**Re: GE-Pittsfield/Housatonic River Site
Floodplain Residential and Non-Residential Properties Adjacent to 1½ Mile Reach of
Housatonic River (GECD710 and GECD720)
Revised Supplemental Soil Evaluation Report and Removal Design/Removal Action
Work Plan Addendum for Selected Phase 2 Floodplain Properties**

***Revised Supplemental Soil Evaluation
Report and Removal Design/Removal
Action Work Plan Addendum for
Selected Phase 2 Floodplain
Properties Adjacent to the 1 ½ Mile
Reach of Housatonic River***

**General Electric Company
Pittsfield, Massachusetts**

March 2007

**PROPERTY BOUNDARY COMPARISON FOR
PARCELS 18-4-2,-3,-4, 18-4-201/202,
18-4-6, AND 18-4-7**

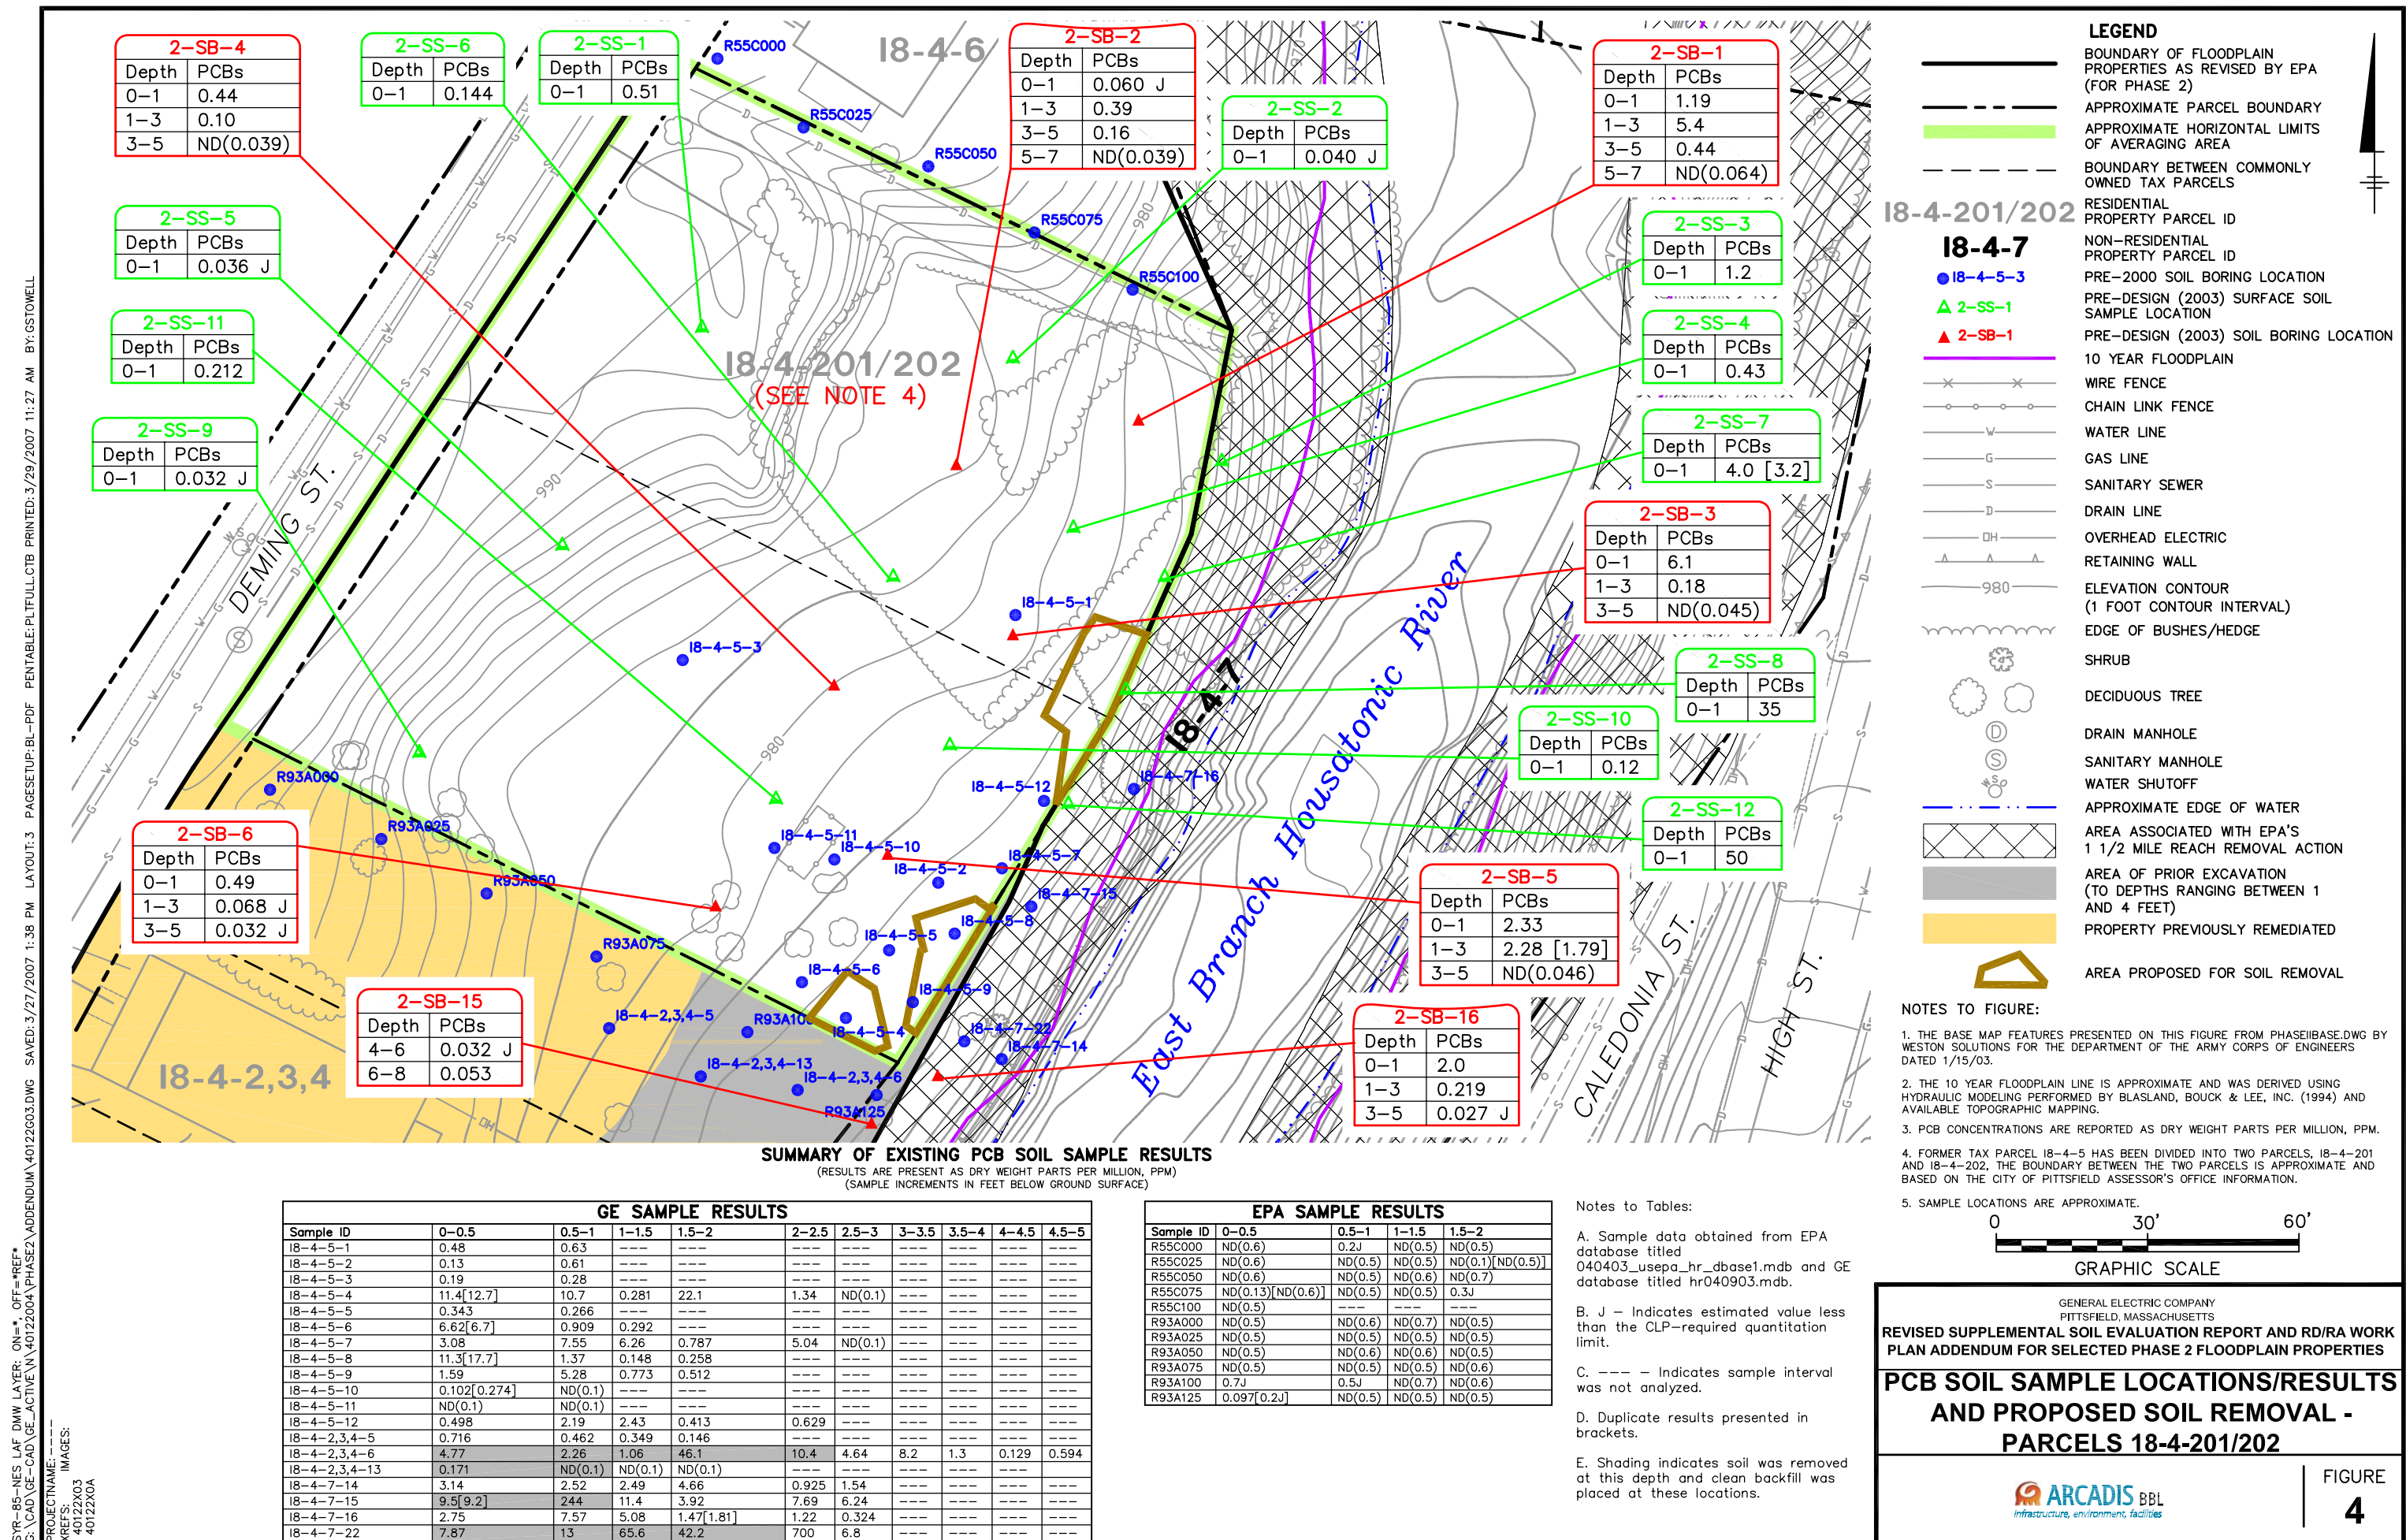
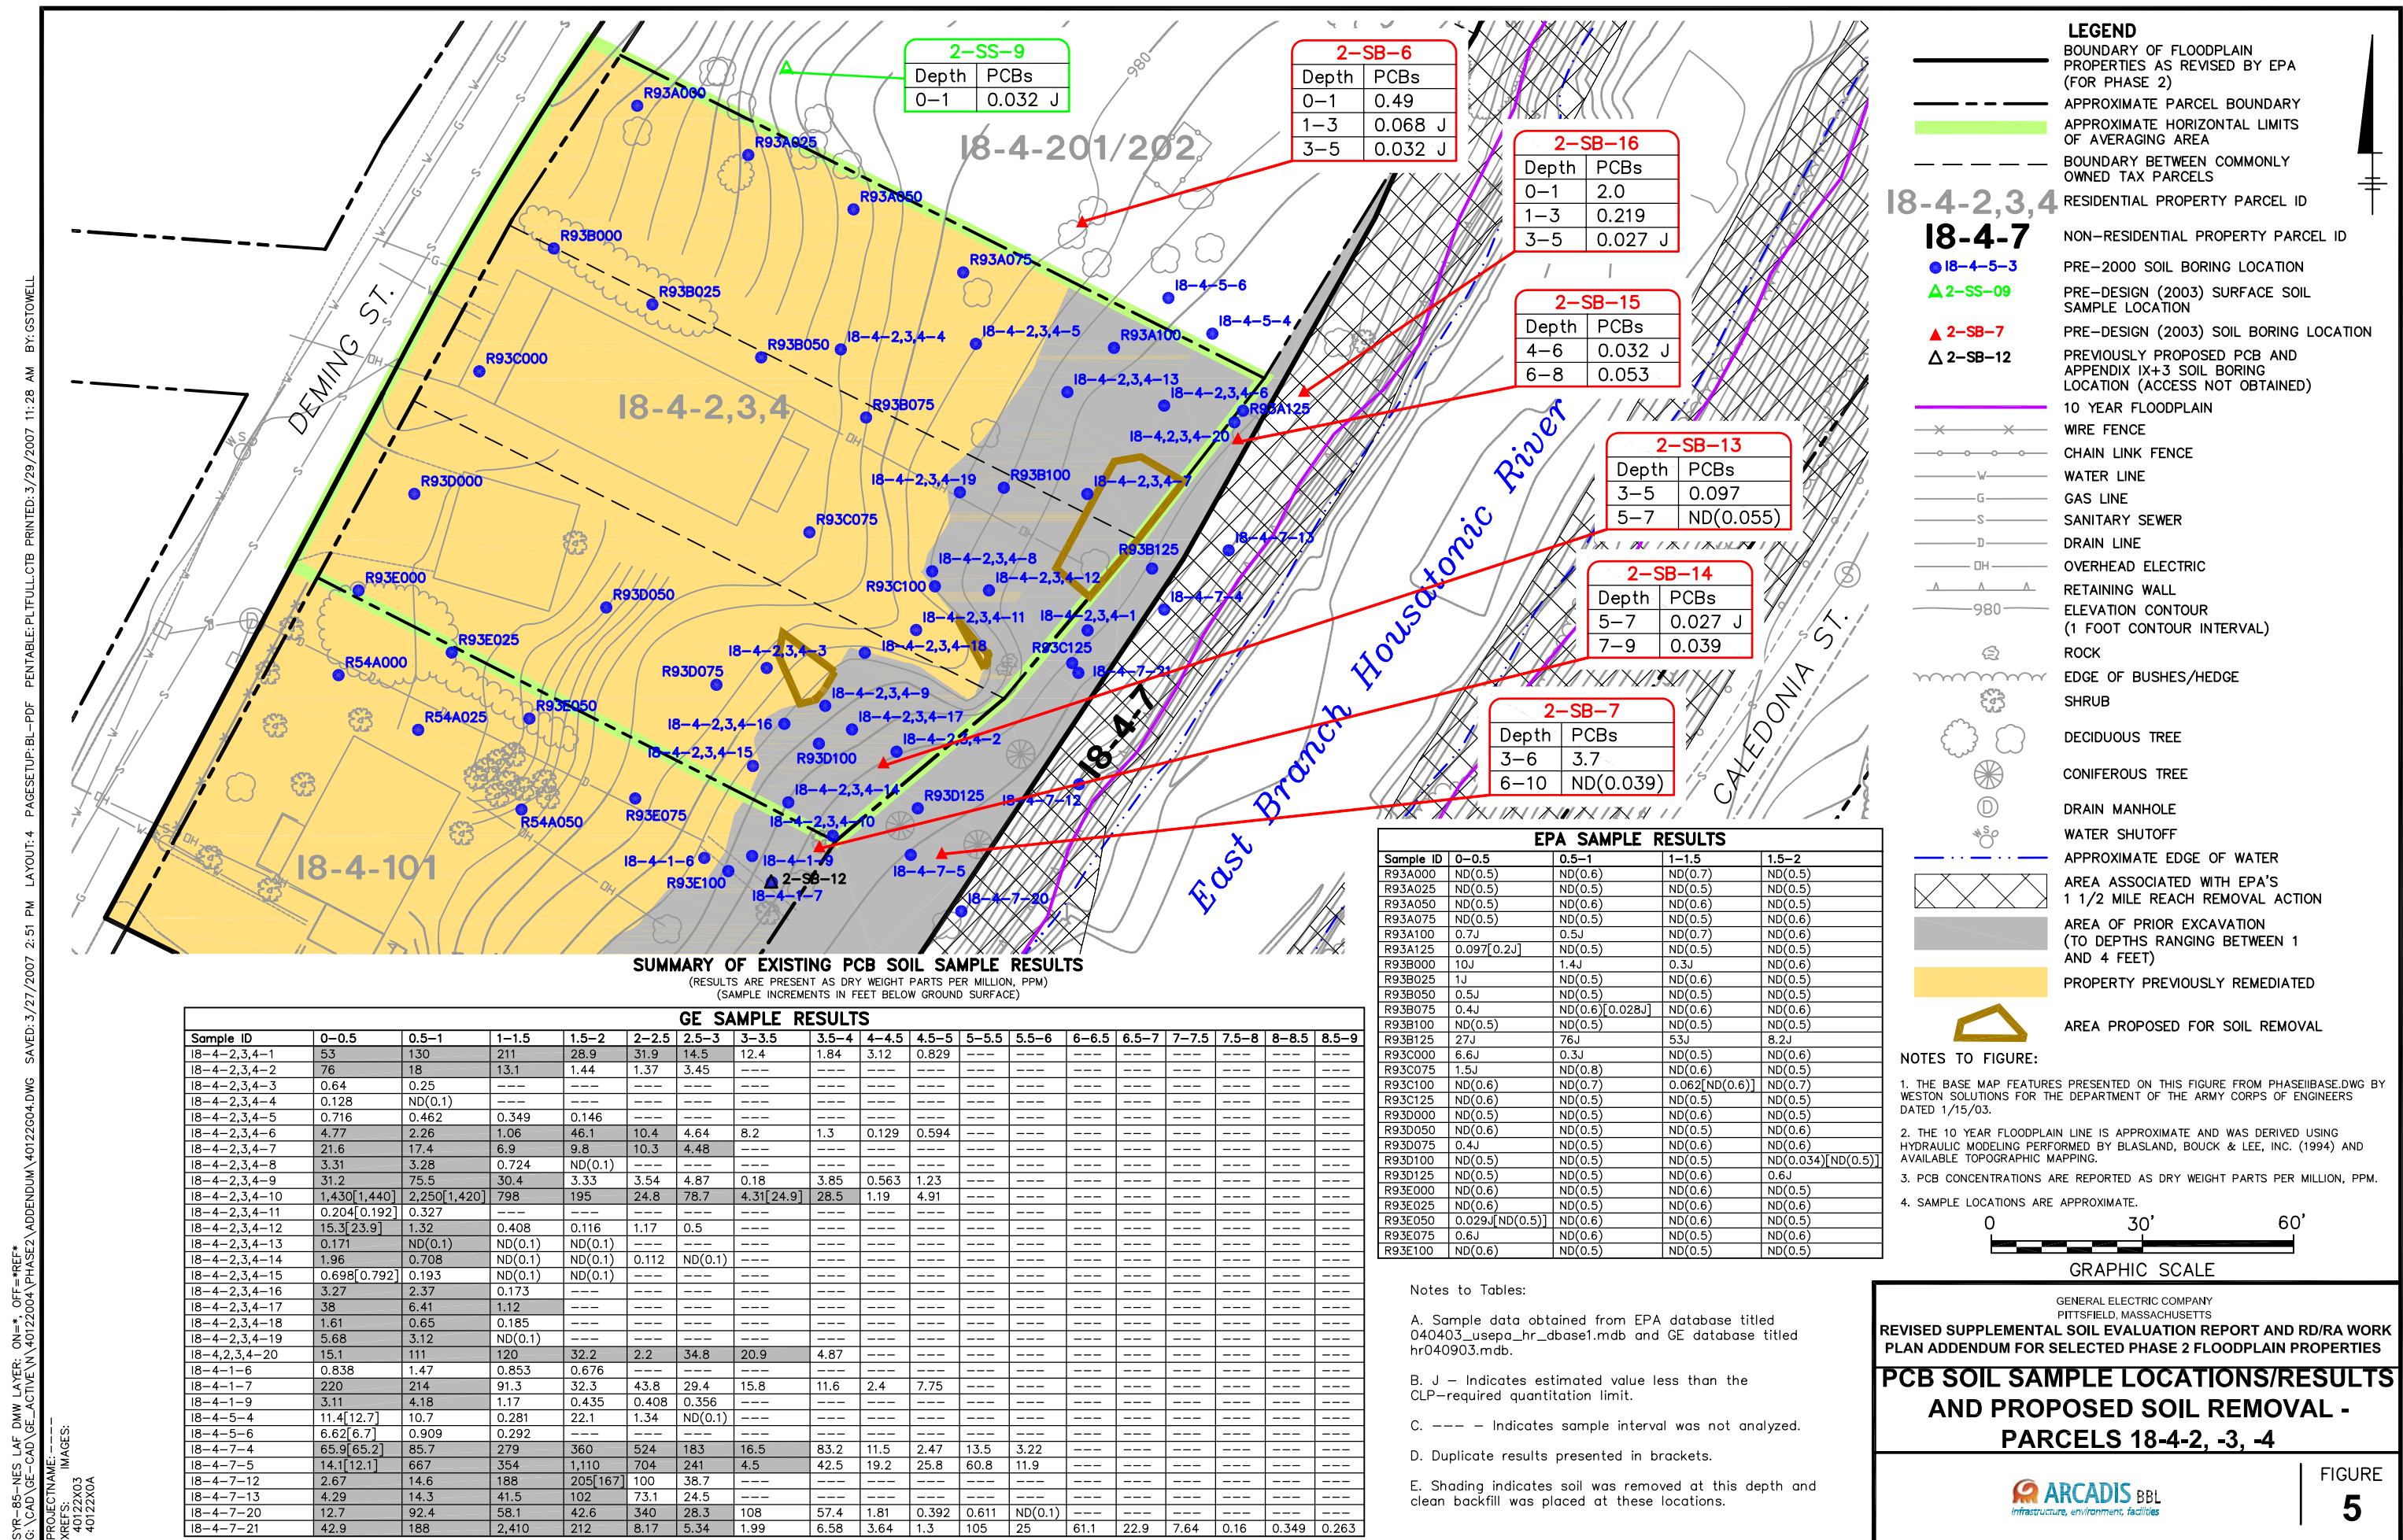
The revised parcel boundaries based on GE's review of the information described in the first paragraph of this section, as well as the revised RAA boundary specified by EPA in its March 8, 2007 letter, are shown on Figure 3 (relative to the prior boundaries), and have been incorporated in all figures in this document.
